IEEE 802.3br D1.0

Proposal to address the editor's note in clause 9.4.5

Replace Figure 99-5 with the following:

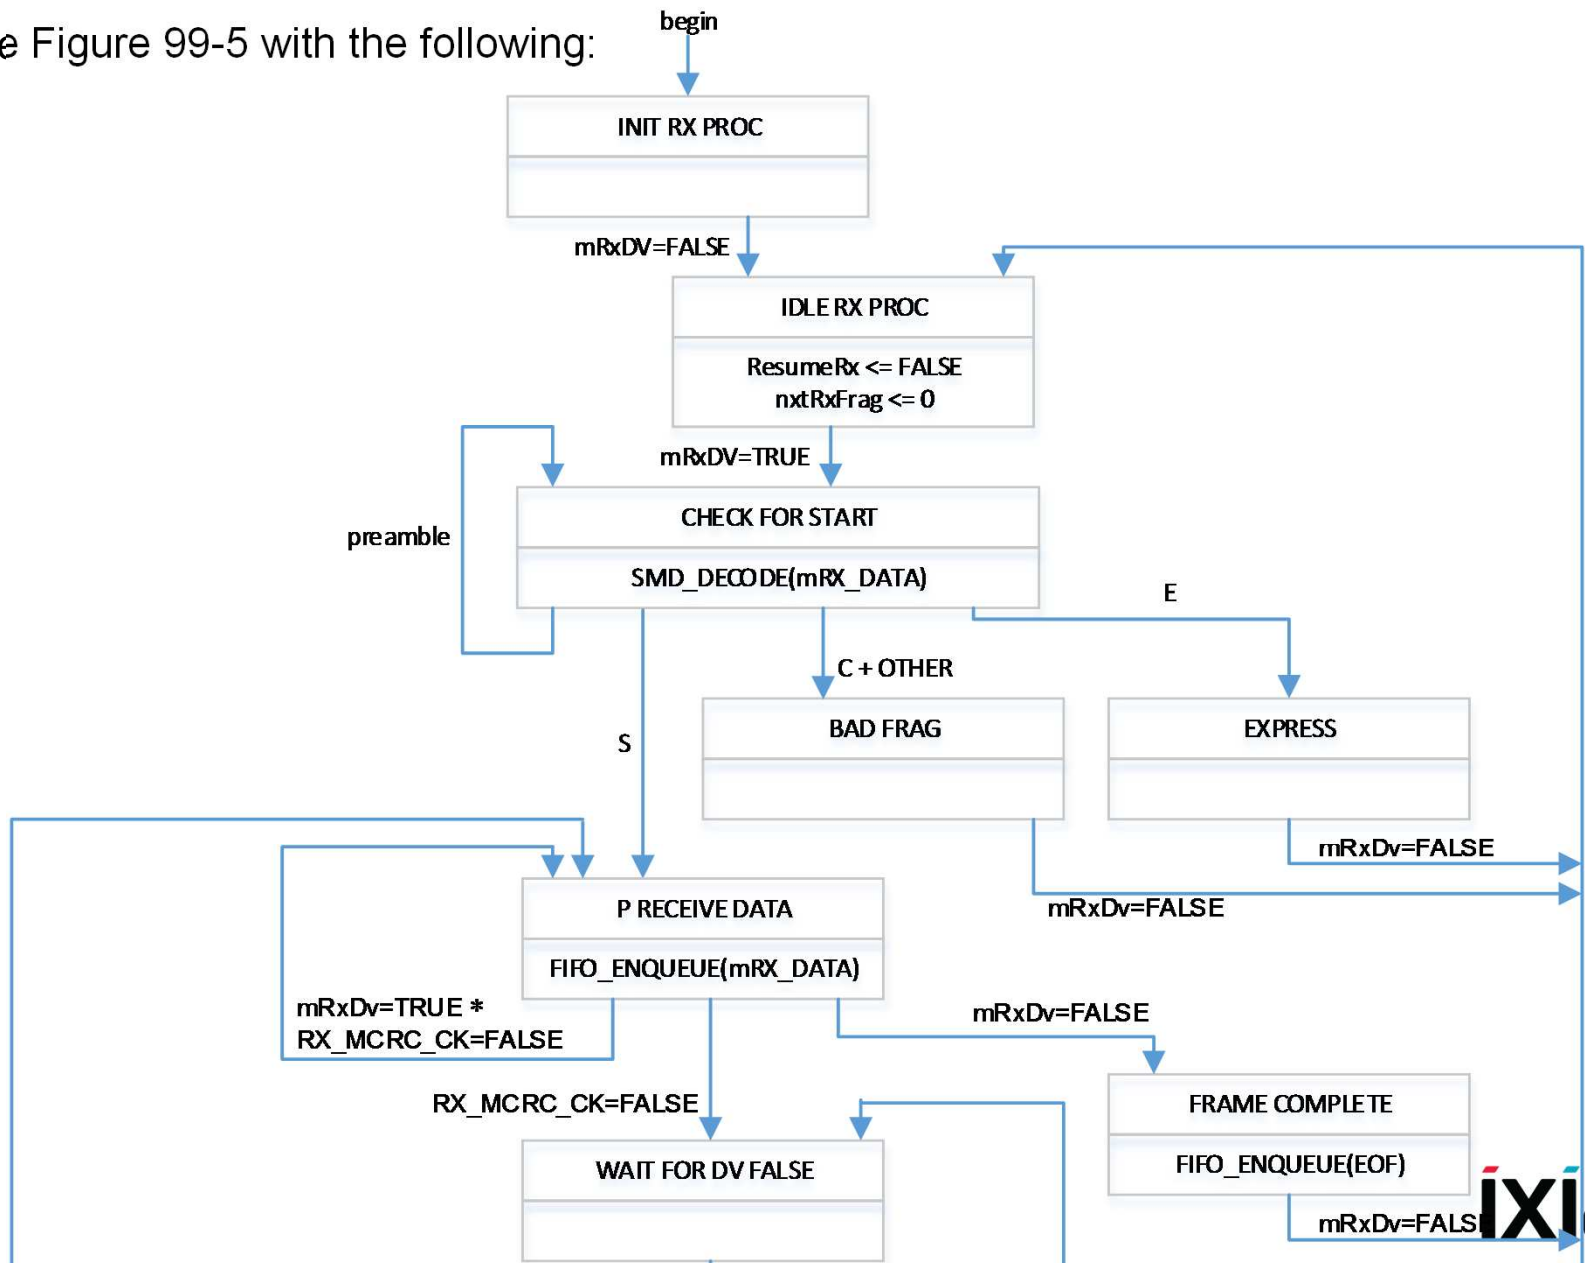
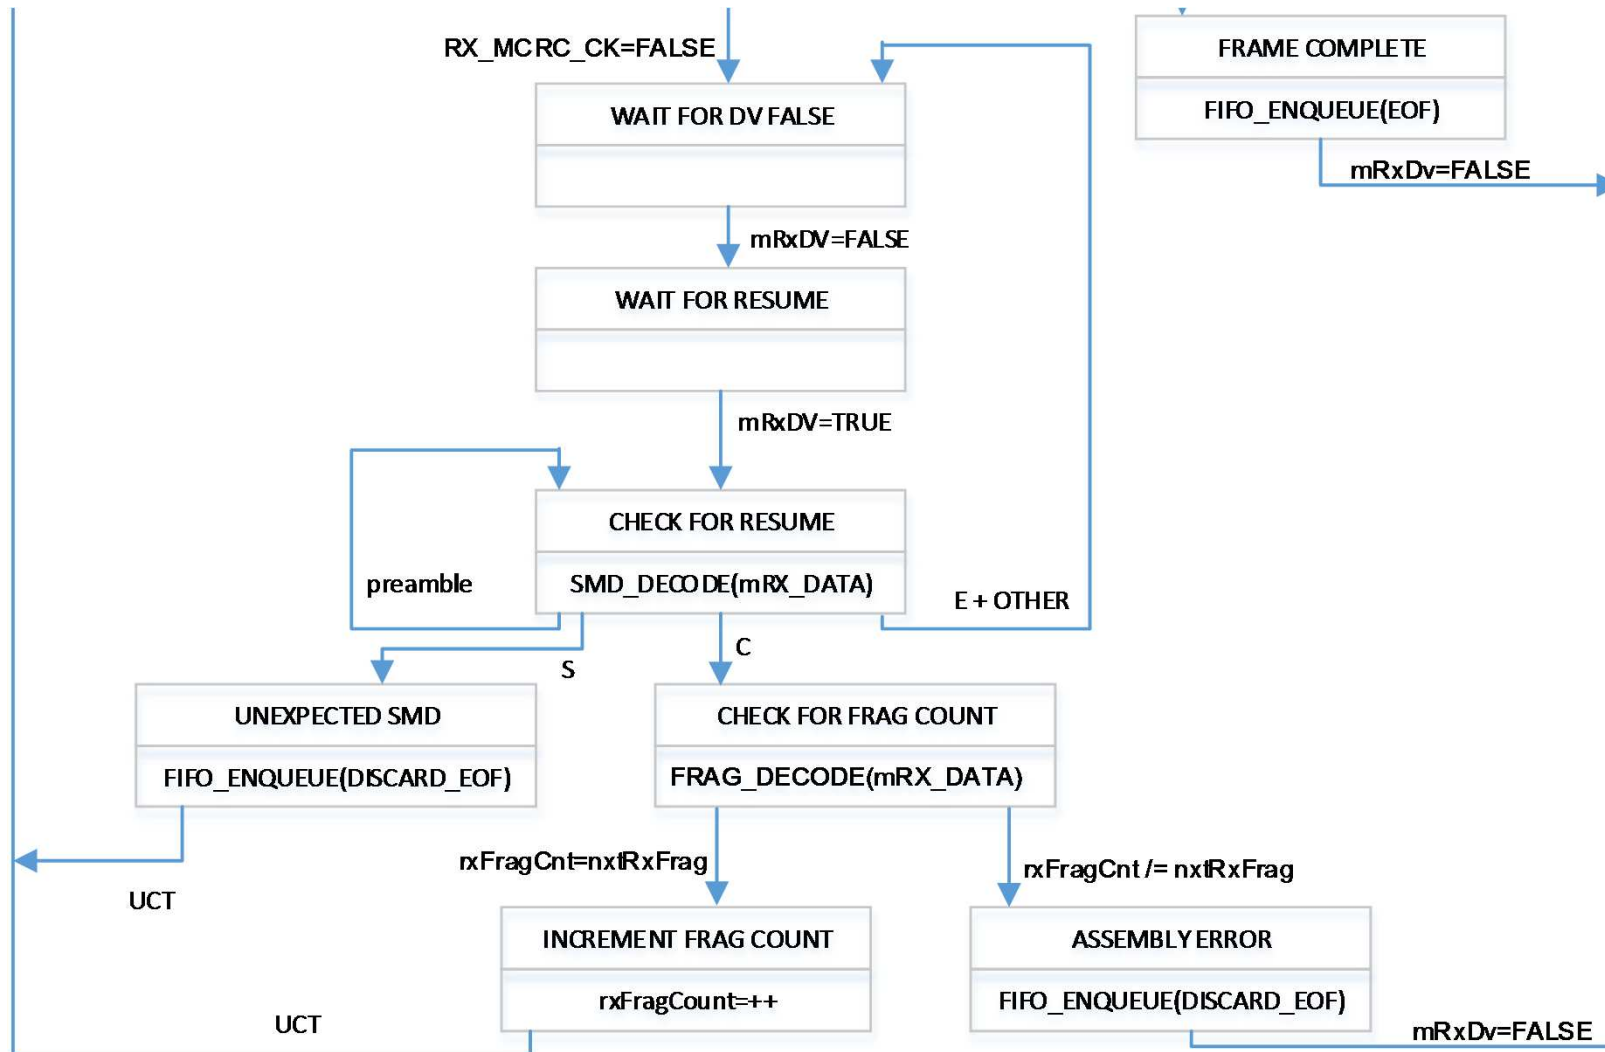
## Alternative 2: Split receive processing into two state machines with a fifo

The receive processing consists of a receive processing input block, a fifo, and the receive processing output block.

The receive processing input block is responsible for parsing and validating incoming mFrames and reassembling such mFrames into Frames.

The fifo provides buffering such that the input block can process a new mFrame while the output block is still forwarding data from the previous mFrame to the pMAC. The fifo should provide enough buffering such that the input block can receive new data while the output block is forwarding a Frame Check Sequence, an IPG, and a preamble to the pMAC.

The receive processing output block is responsible for passing data to the pMAC, ensuring that the pMAC will detect a FrameCheckError due to any reassembly errors, and ensuring that there is a valid IPG in all frames sent to the pMAC

Replace Figure 99-5 with the following (continued):
